SWIM PROJECT PROFILE		File No. : 194
Regist. No. : Agency No. : BSWM-113	Name: LABOON SWIP	
Region: 8	Province: SOUTHERN LEYTE	Municipality: MAASIN
Present Status: 1. Pre-F/S( )    ② F/S(1983)    ③ D/D(1983)		
Purpose: Major : Irrigation Incidental : IF, FC, WM		
Project Feature:

SWIM PROJECT PROFILE		File No. : 195
Regist. No. : Agency No. : BSWM-114	Name: POLANQUI SWIP	
Region: 8	Province: EASTERN SAMAR	Municipality: TAFT
Present Status: 1. Pre-F/S( ) ② F/S(1983) ③ D/D(1983)		
Purposo: Major : Irrigation Incidental : IF, FC, WM		
Project Feature:

SWIM PROJECT PROFILE		File No. : 222
Regist. No. : Agency No. : BSWM-142	Name: BOLTON SWIP	
Region: 11	Province: DAVAO DEL SUR	Municipality: MALALAG
Present Status: 1. Pre-F/S( ) (2) F/S(1983) (3) D/D(1983)		
Purpose: Major : Irrigation Incidental : IF, FC, WM		
Project Feature:

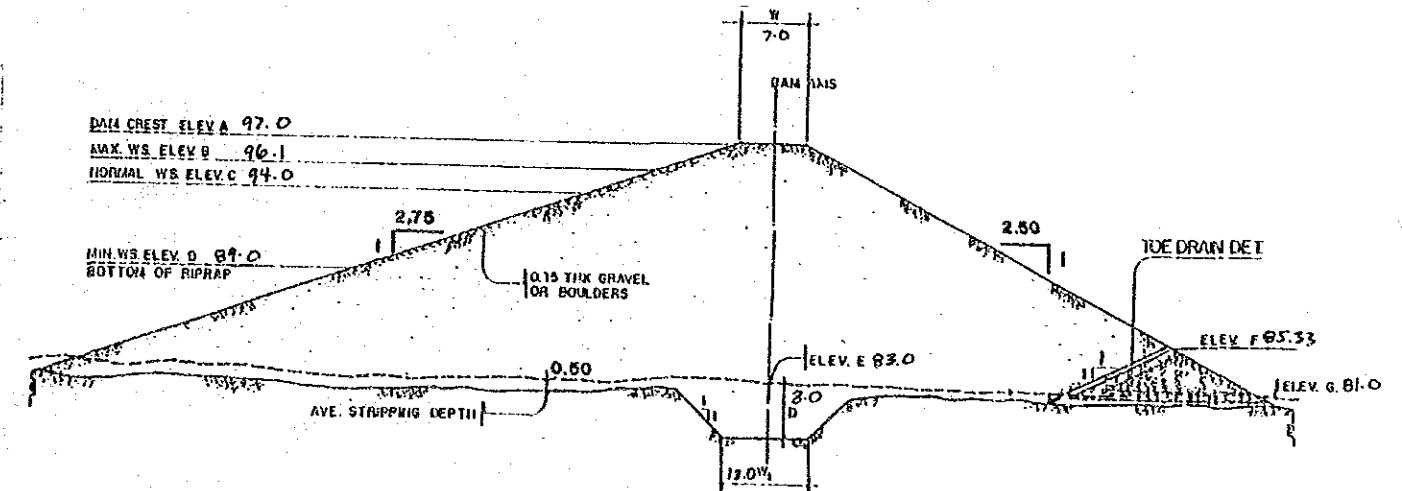
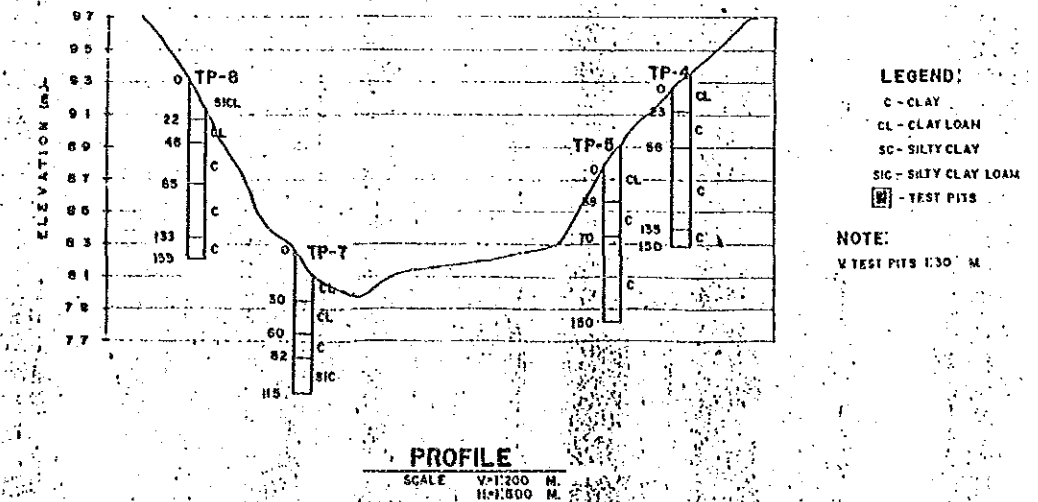
2. Planning Environmental conservation plan is not formulated.		
3. Design Depth of core trench shall be modified during construction. Stability of upstream slope of the dam shall be checked. Design discharge shall be estimated based on 100 year's flood or more. Center line of the spillway shall be shifted to right side. Weir shall be provided in the spillway. Center line of conduit is recommended to be straight.

SWIM PROJECT PROFILE		File No. : 223
Regist. No. : Agency No. : BSWM-143	Name: PEDTAP SWIP	
Region: 12	Province: NORTH COTABATO	Municipality: CABACAN
Present Status: 1. Pre-F/S( ) (2) F/S(1983) (3) D/D(1983)		
Purpose: Major : Irrigation Incidental : IF, FC, WM		
Project Feature:

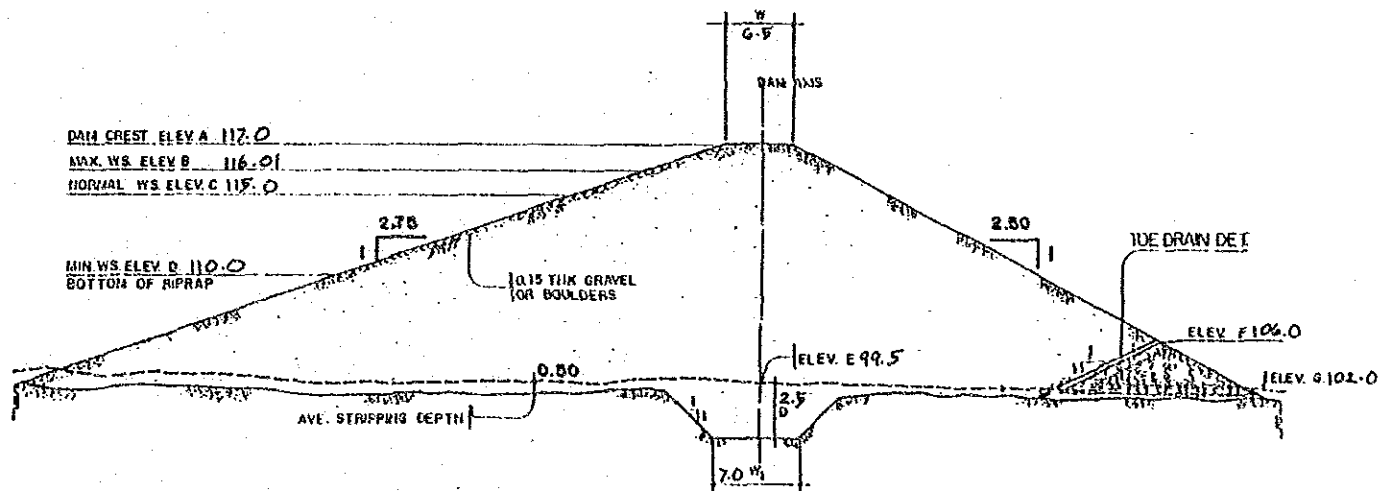
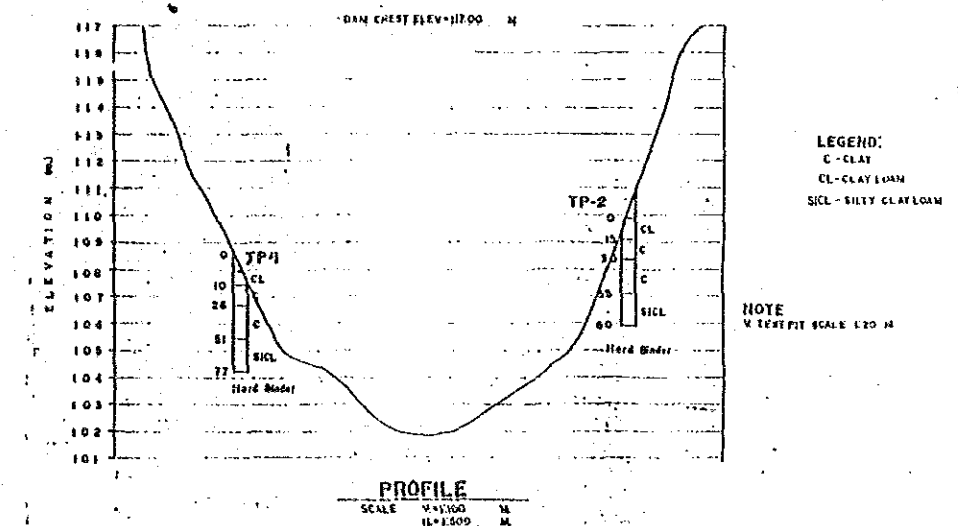
2. Planning Environmental conservation plan is not formulated.		
3. Design Depth of core trench shall be modified during construction. Stability of upstream slope of the dam shall be checked. Design discharge shall be estimated based on 100 year's flood or more. Weir shall be provided in the spillway. Center line of conduit is recommended to be straight.
